How to remove the automatic braking (on power off) in the SCP1

This document applies ONLY to the first version (small retriggerable fuse) of the SCP-1 analog cartridge, positive polarity (common ground). For later versions, a dip-switch is provided to the same effect, please refer to the most recent version of the manual.

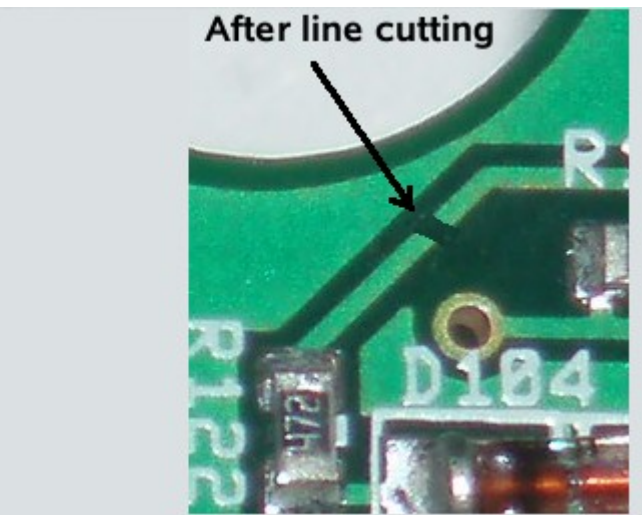
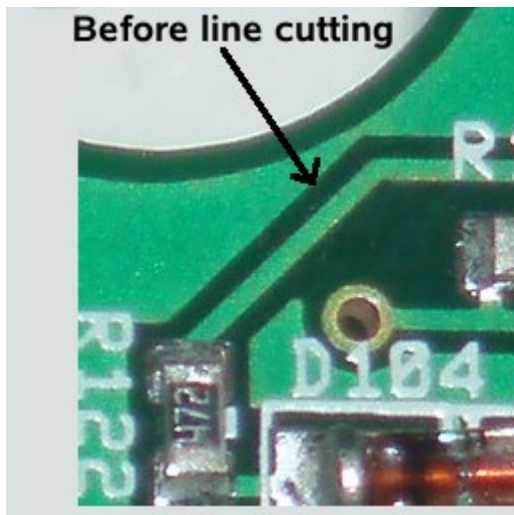
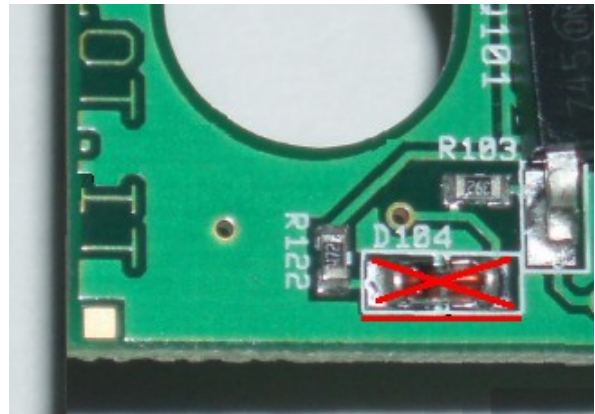
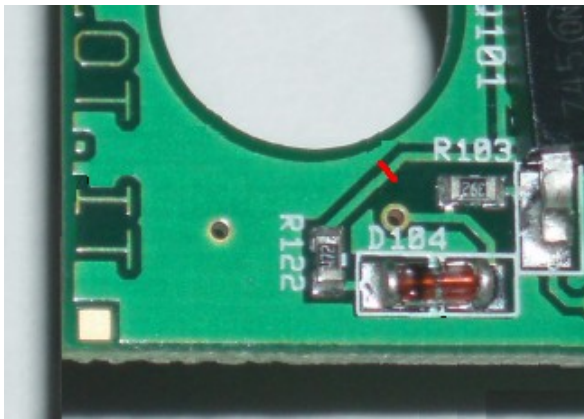
2. Cut the RED line with a cutter's edge, or ALTERNATIVELY, remove diode D104
